DEER Measure Database Update (January 2010)

Version 3.02 of the DEER measure database is the update to the mid-December DEER 2008 release for 2009-2011 Energy Efficiency Planning/Reporting. It was created with a new version of the DEER measure analysis software (MAS). The new MAS tool includes a number of changes and additions to the previous version that results in an improved and expanded DEER measure database. The database structure and the database viewing tool, MISer, have also been updated for this database release.

Figure 1. Showing a large decrease in the gas heating "take back" associated with a lighting measure in the **Multi-Story Retail**, **Existing Vintage** prototype

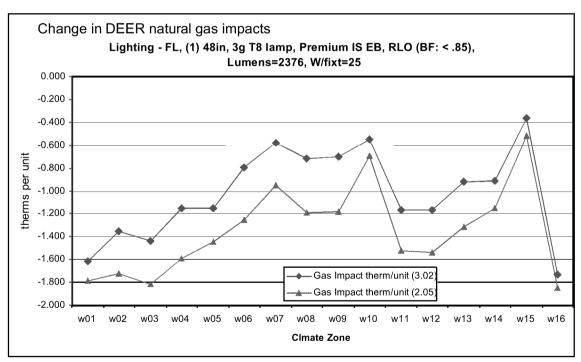
Figure 1 shows the large decrease in the negative gas impacts for a lighting measure in the multi-story retail building prototype. This result is typical of prototypes with central plant HVAC systems and is largely due to changes in the control mechanism of the oldest vintage HVAC system and the fix to the boiler sizing.

Figure 2. Showing a small change in gas heating "take back" associated with a lighting measure in the **Small Office Building, Existing Vintage** prototype

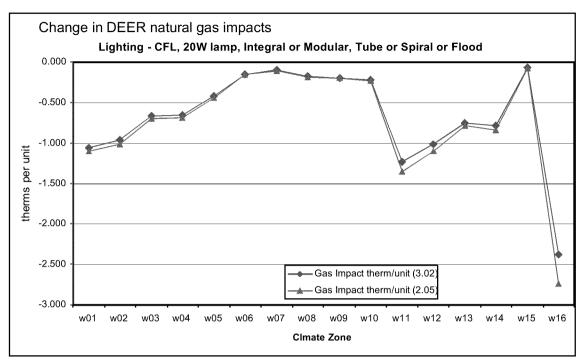
Figure 2 shows the same type of results for the small office building prototype, a building with packaged HVAC equipment. In this case, there is very little difference in the negative gas impacts since the two changes mentioned above do not apply to packaged HVAC equipment.

Figure 3. Showing the change in demand impacts for climate zones CZ01, CZ03 and CZ05 for the **Large Office Building**, **2002-2005 Vintage** prototype

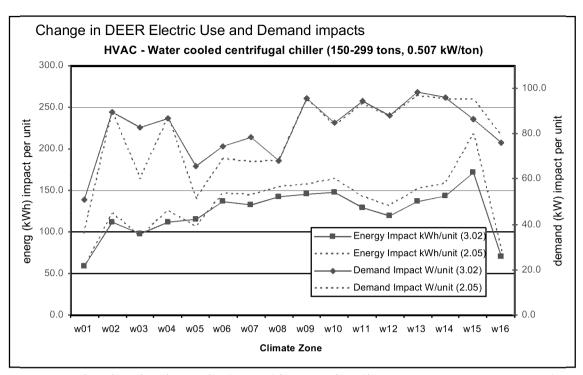
Figure 3 shows the energy and demand impacts for the recent vintage large office building prototype. The change in demand savings in climate zones CZ01, CZ03 and CZ05 is due to the design chiller size decreasing by approximately 20% in these climate zones. The change in chiller design size is a direct results of the economizer set point issue discussed above.

Figure 4. Showing the decrease in gas savings per kBTUh capacity of the hot water system for the **Small Office Building, Existing vintage** prototype

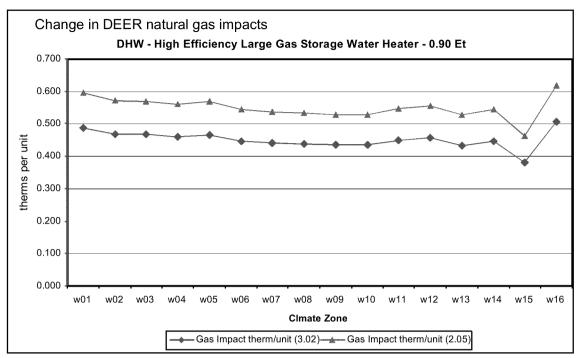
Figure 4 shows the decrease in the gas energy savings per kBTUh capacity for a hot water system in the small office prototype. This decrease per unit of capacity is due to the increase in assumed heating capacity of the hot water system, as discussed above. The actual energy savings in total therms is actually slightly larger in the new version, but the capacity increased by 25% in this case.

Figure 5. Showing a significant decrease in electricity energy and demand savings for an HVAC measures applied to the **Mobile Home, Existing Vintage** prototype

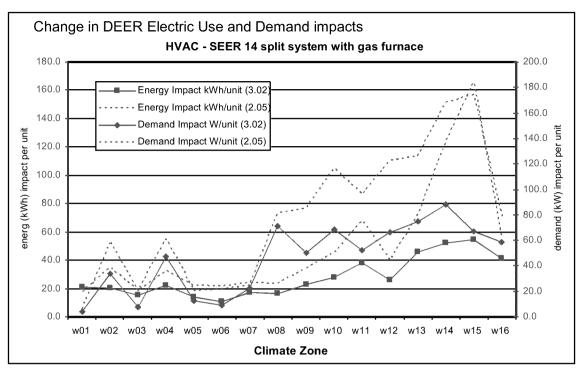
For the residential models, the largest change in the results is due to the DOE2.2 bug-fix that corrected the amount of outside air associated with duct losses to the outside. Figure 5 shows a significant drop in the demand and energy savings in most climate zones for a SEER 14 HVAC measure applied to the mobile home prototype. The earlier database savings values were exaggerated, especially in the hotter climate zones, due to the bug that increased the cooling and heating loads and made the duct system appear to be extremely inefficient. The mobile home prototype is assumed to have no return ductwork, thus all duct leakage is lost to the outside. The DOE2.2 code was basically doubling duct air losses to the outside before the bug fix.

Figure 6. Showing a small change in electricity energy and demand savings for an HVAC measures applied to the **Single-Family, Existing Vintage** prototype

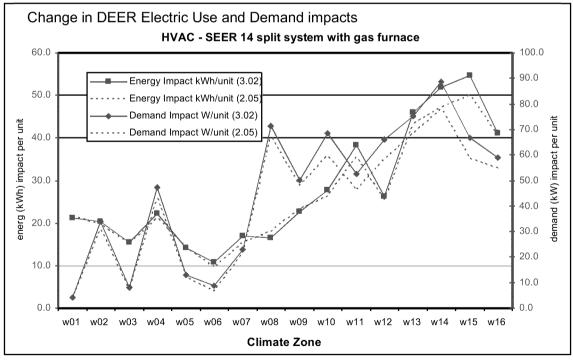
This issue did not impact the single-family residence to the same degree, as a smaller fraction of the total duct air loss is assumed to be to the outside. Figure 6 shows the same impacts for the single-family residence; in this case the savings increase overall, and the largest decrease is on the order of a few percent.
